COMMUNITY BOARD FEEDBACK PACKAGE

Business Name: CAFETERIA

Cafe Address: 119 7 AVENUE, NEW YORK, NY, 10011

Application Number: 20240711010018

*PROPOSED SITE PLAN

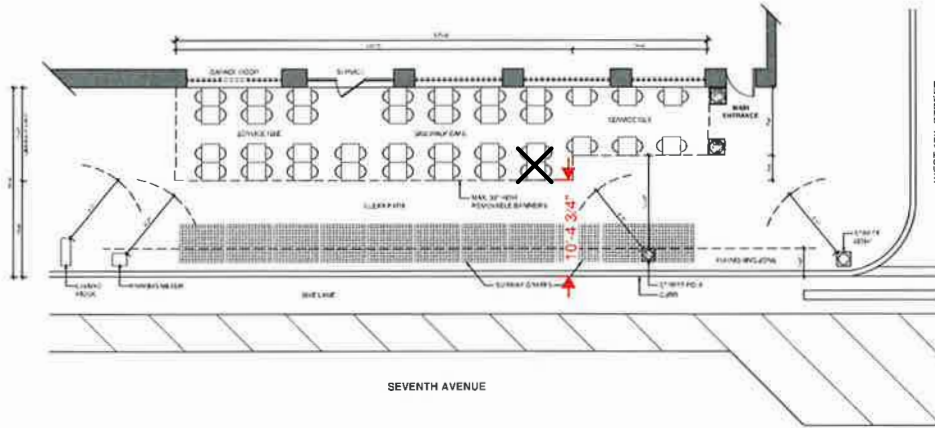
The proposed Site Plan is problematic in that it does not provide for the required 10 foot pedestrian clear path across the entire length of the sidewalk cafe, particularly around the tree pit near the south end of the cafe.

This applicant's current sidewalk cafe is surrounded by a fully-enclosed, permanent-appearing structure. Applicant does not have a permit for an enclosed sidewalk cafe, so their current structure is not allowed and also restricts visibility and pedestrian flow.

MCB4 recommends Denial, unless the sidewalk cafe Site Plan were reconfigured to provide for the required 10 foot pedestrian clear path by removing two tables with two seats each at the point near the tree pit where the cafe expands from two tables to four tables (as indicated on the marked-up Proposed Site Plan). MCB4 also requests that any approval of the present application be conditioned on applicant's immediate removal of the entire enclosure surrounding their current sidewalk cafe and applicant's firm commitment not to enclose any sidewalk cafe in the future.
